T16IZ SOFTWARE UPDATE CHANGES

This software updates or alters the functions and features noted below. The instructions and information that follow are meant as a supplement to the original instruction manual that accompanied the T16IZ transmitter. Please refer to the original instruction manual where applicable, but replace the steps indicated below with these instructions. Please check to ensure that the update has been installed.

V3.3

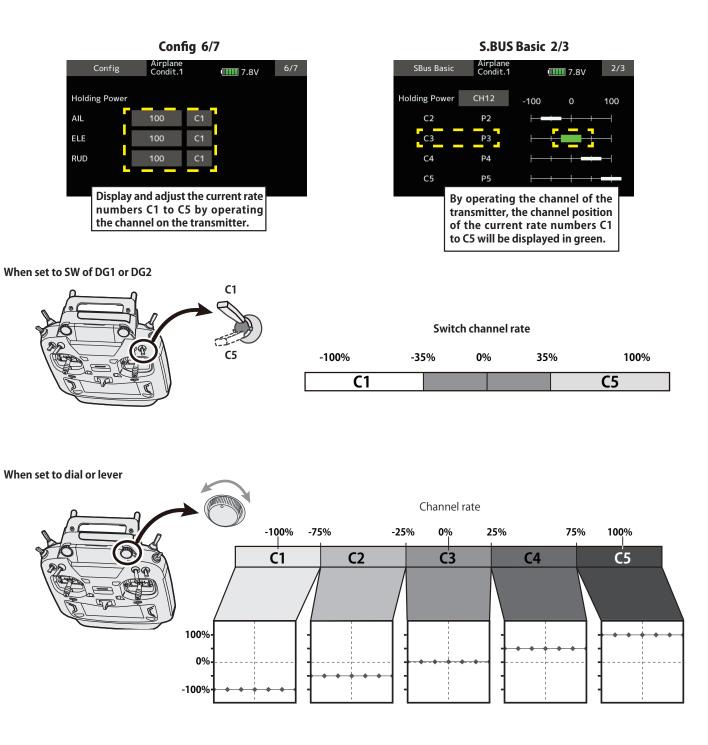
- 1. CH3 (THR) can be output to the RUD2 / S.BUS2 port.
- 2. The Holding Power rate of the aircraft in AVCS mode has been expanded to 5 types from C1 to C5, and each rate can be set by switching the display.
- 3. Added the setting of switching CH of Holding Power rate C1 to C5 to S.BUS basic menu.

The current rate numbers C1 to C5 are displayed by operating the channel of the transmitter.

Like the flight condition function of the transmitter, you can set up to 5 different data for the attitude holding force rate of the aircraft in AVCS mode by operating the switch from the transmitter, and switch between them. You can set the holding power rate selector switch to the channel with the AFR function of the transmitter, and set the point for each rate on the AFR point curve to switch. It is also possible to use the flight condition function to work with the flight condition switch.

2. O.S.ENGINE EM-100 New firmware Version 9.11 support.

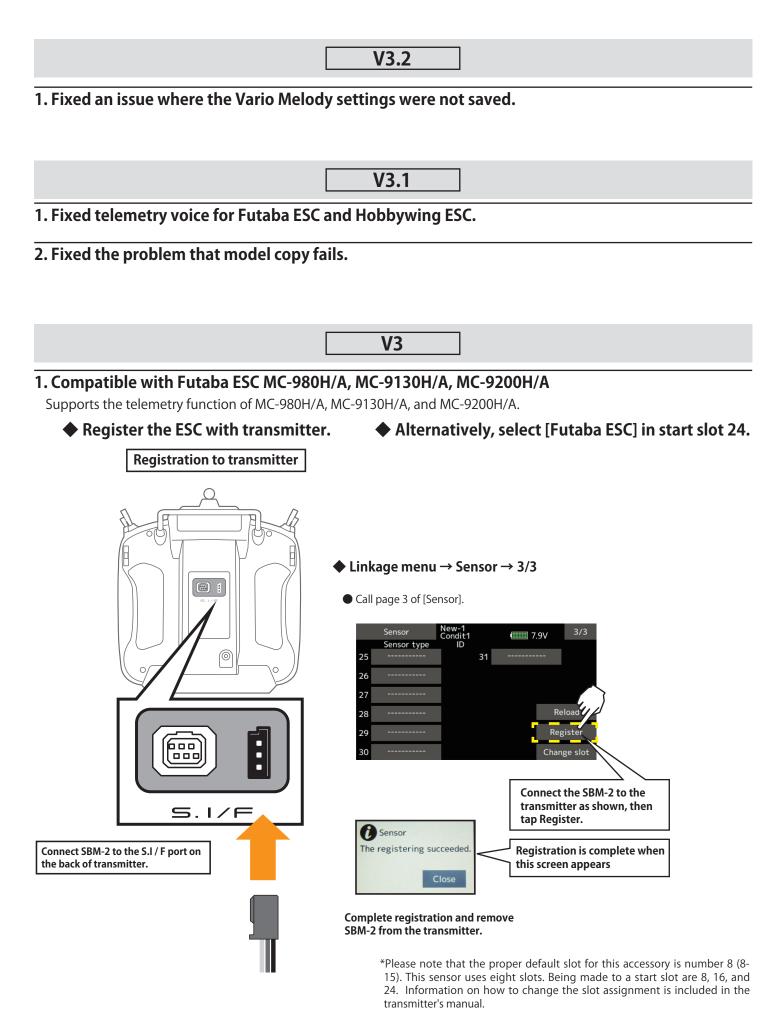
If you have used the EM-100, the update will unregister the EM-100 from the "Sensor" screen. Register the EM-100 again on the "Sensor" screen.
